YMP-007-R2  
10/28/91YUCCA MOUNTAIN SITE CHARACTERIZATION PROJECT  
INTERIM CHANGE NOTICEICN No. 2  
Page 1 of 1

Title: STAGING, PACKAGING, AND DOCUMENTING NEUTRON-ACCESS BOREHOLE SAMPLES	Document No.: BTP-SMF-013	Rev. No.: 0	Effective Date: 1/13/92
--	------------------------------	----------------	----------------------------

ICN No.: 1  
Page 1 of 3

Title: Staging, Packaging, and Documenting Neutron-Access Borehole Samples	Document No.: BTP-SMF-013	Rev. No.: 0	Effective Date: 10/29/91
--	------------------------------	----------------	-----------------------------

Figure 1 flowchart

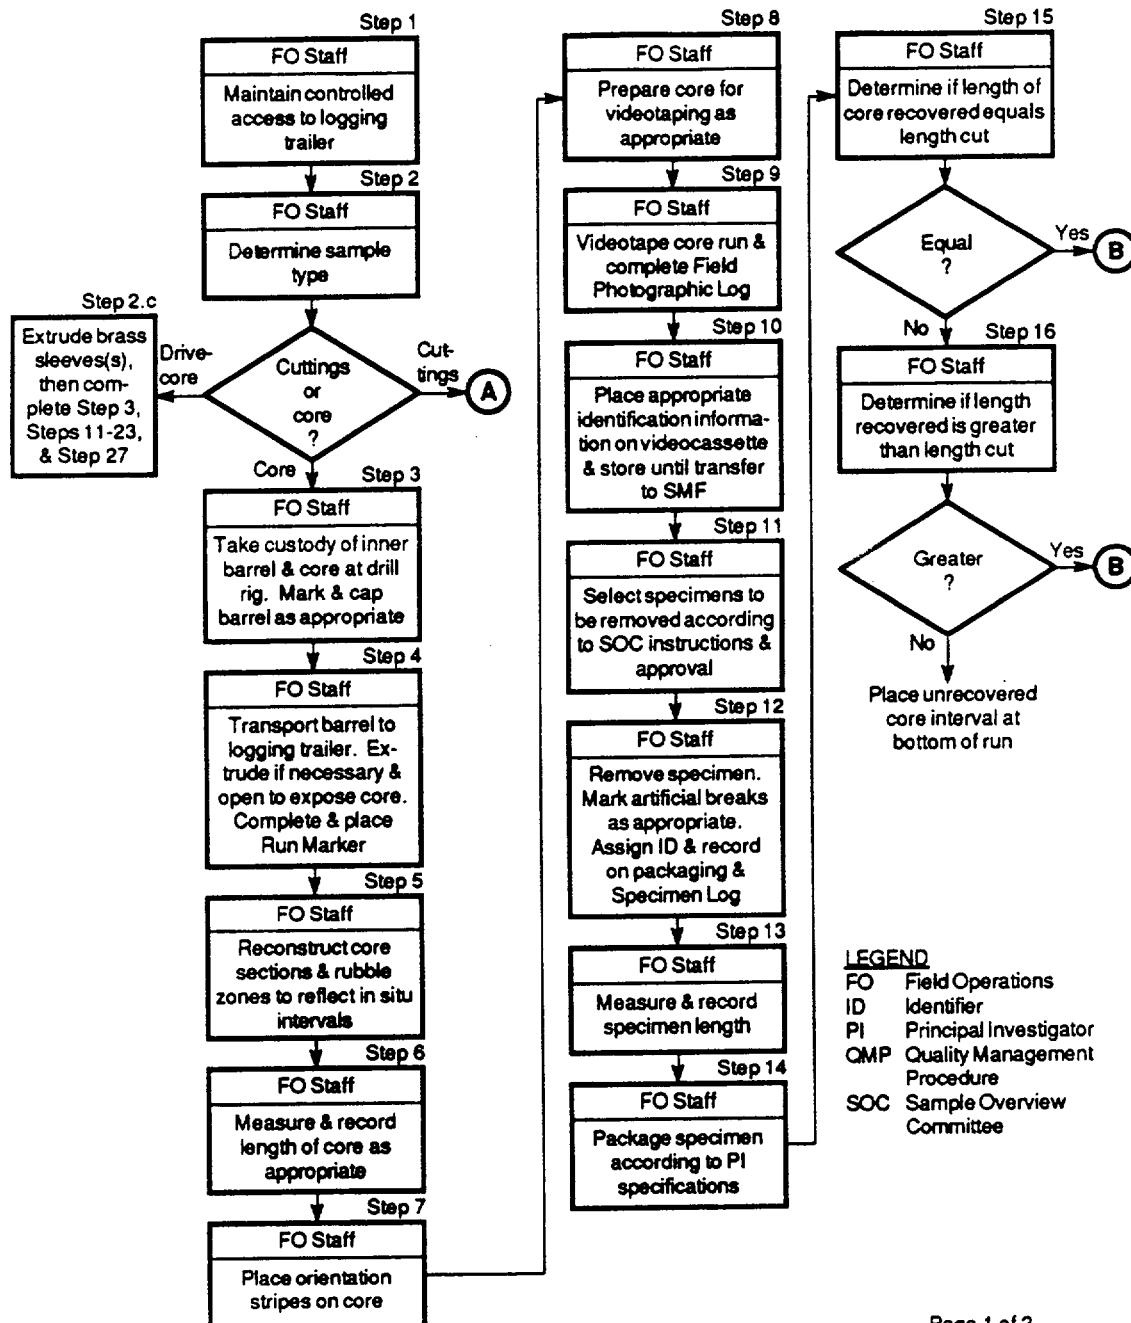
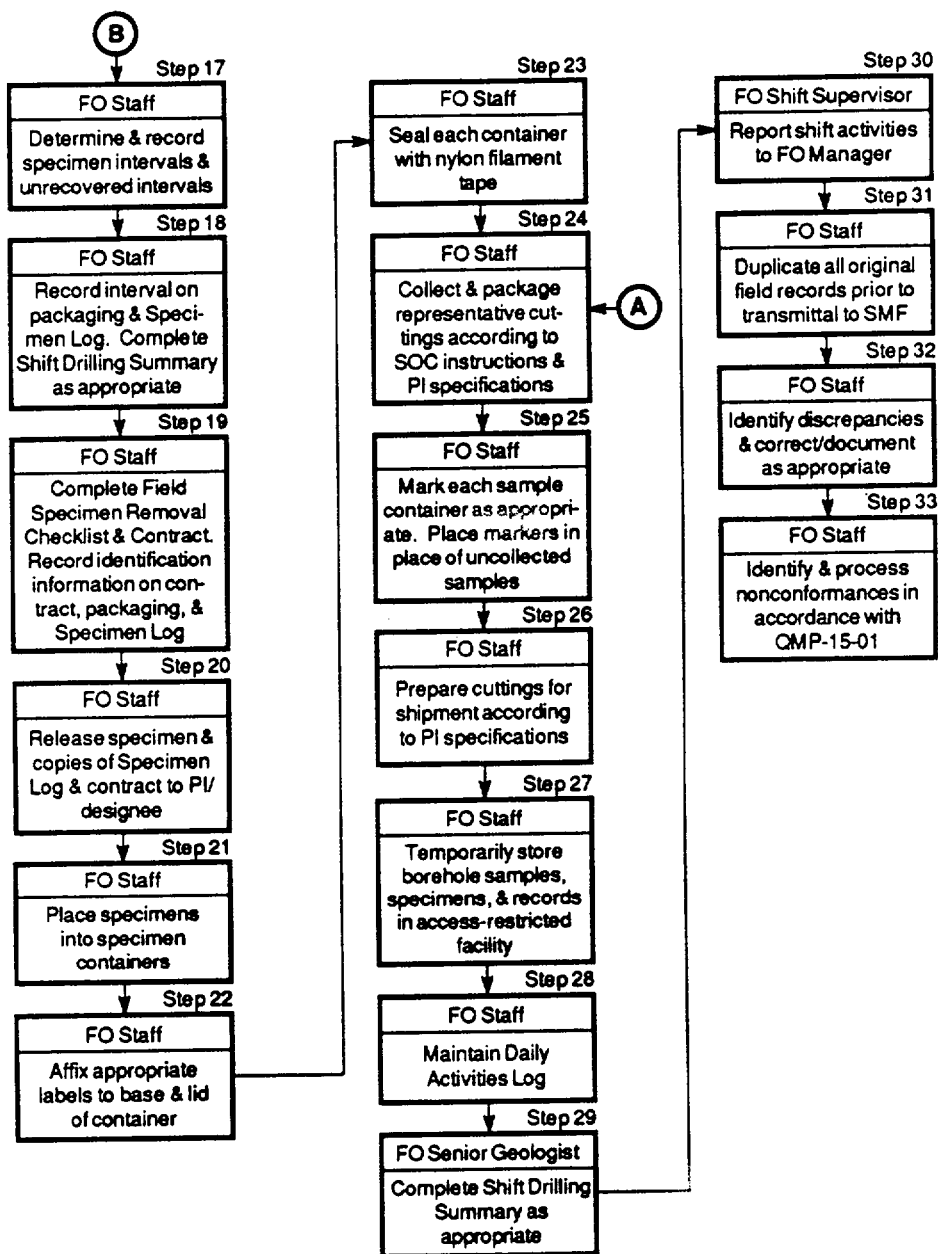
Page 12 of 23 and Page 13 of 23

Modify to reflect above changes as appropriate.
